50-255 CE PALISADES

CONVERSTION TO IMPROVED TECH SPECS -RESPONSE TO 7/27/98 RAI

CONSUMERS ENERGY COMPANY PALISADES PLANT DOCKET 50-255

CONVERSION TO IMPROVED TECHNICAL SPECIFICATIONS RESPONSE TO JULY 27, 1998 REQUEST FOR ADDITIONAL INFORMATION

NUREG pg 3.8-9 JFD 3.8.1 pg 3 of 3

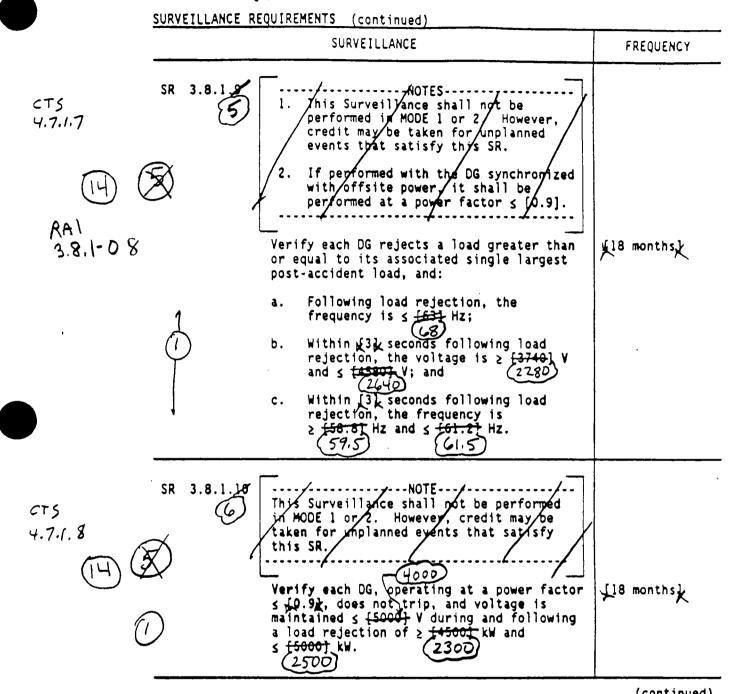
Comment: JFD 5 did not address these issues. Revise the submittal to provide the technical justification for not adopting the Note or conform to the STS.

A new JFD (JFD 14) has been provided to clarify why Note 1 to ISTS SR 3.8.1.9 was not adopted in the ITS.

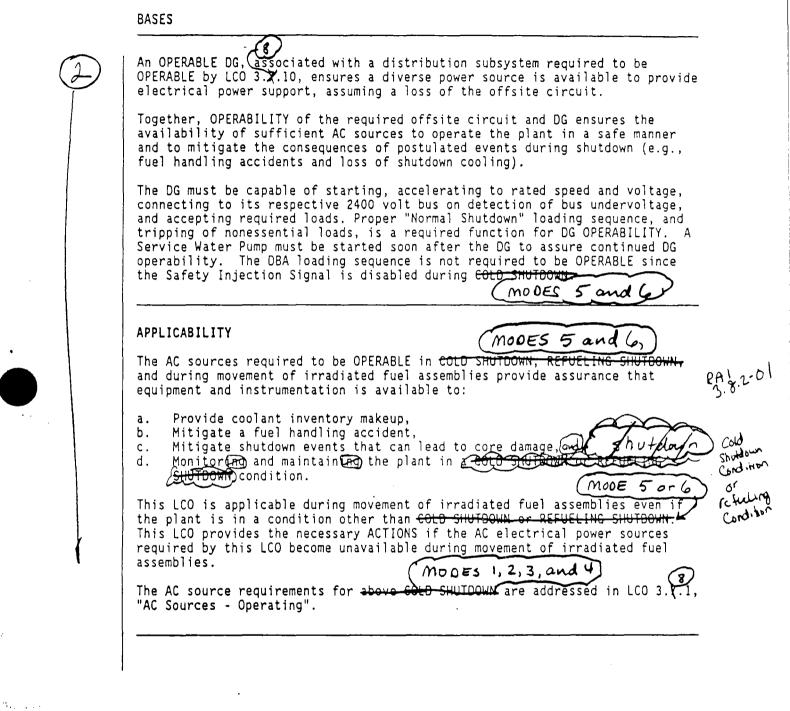
Comment: This is not a justifiable plant specific difference. Revise the submittal to conform to the STS.

The terminology used to describe the plant condition in item "d" of the ITS Applicability has been revised to conform with the terminology used in the ISTS. Conforming changes have also been made to CTS Bases markup page B 3.7.2-2.

d. Monitor and maintain the plant in a s hutdown refueling condition.					
	This LCO is applicable during movement of irradiated fuel assemblies even if the plant is in a condition other than MODES 5 and 6. This LCO provides the necessary ACTIONS if the AC electrical power sources required by this LCO become unavailable during movement of irradiated fuel assemblies.					
	The AC source requirements for MODES 1, 2, 3, and 4 are addressed in LCO 3.8.1, "AC Sources - Operating."

ACTIONS (continued) <u>F.1</u>

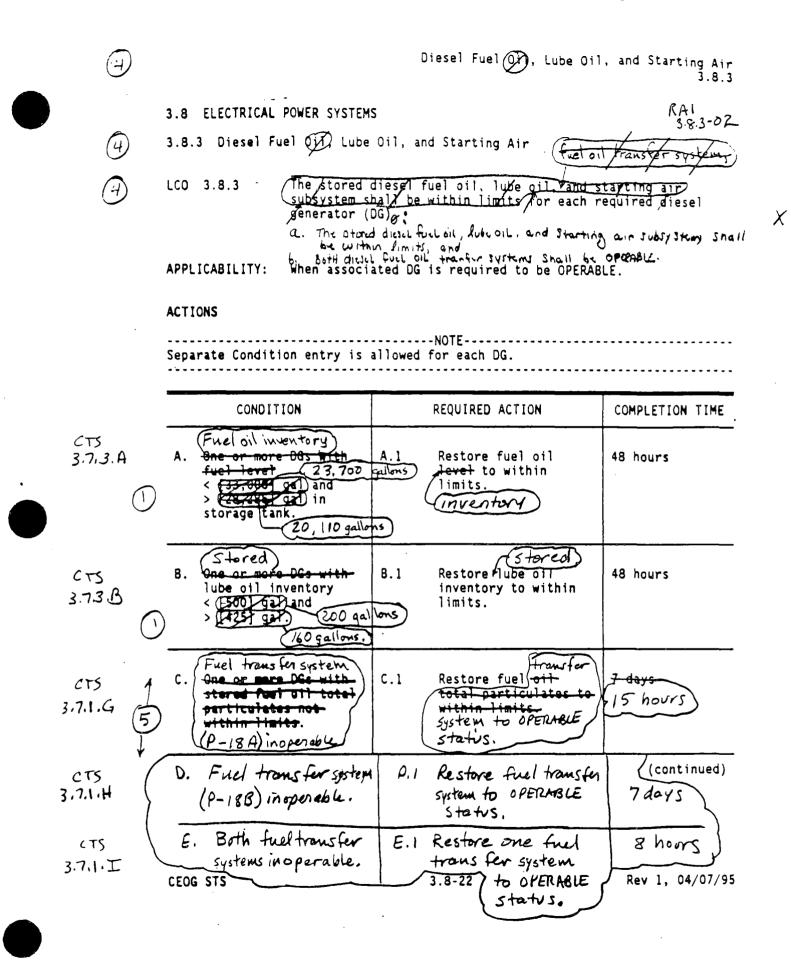
Comment: Revise the submittal to expand the Bases for ITS 3.8.3 Required Action G.1 to address starting air.

The Bases for ITS 3.8.3 Required Action G.1 has been revised to include the starting air subsystem.
